David Clark Company Incorporated
360 Franklin Street, Box 15054
Worcester, MA 01615-0054
Phone: 508-751-5800 Fax: 508-753-5827
www.davidclark.com

RE: FCC: Y3J-DCCI-BT
IC: 9409A-DCCIBT

David Clark Company Inc., hereby declares that all production units of our Model DC ONE-X Aviation Communications Headset have incorporated the modifications defined in Test Report 511-15 Issued 2/12/16, on page 3 in section 2.8 titled EMC Modifications. Specifically we have incorporated the pi filter in series with the Bluetooth antenna, (ANT1):

This is shown on Page 3 (of 10) on our In-Line PCBA Schematic, 43000G-17EL-MAS Rev D. The specific portion of that circuit is pasted below:

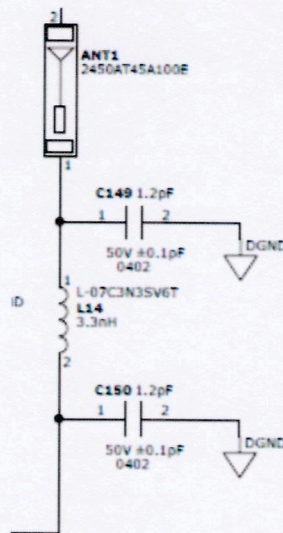
- Shunt 1.2 pF (C150)
- Series 3.3 nH (L14)
- Shunt 1.2 pF (C149)
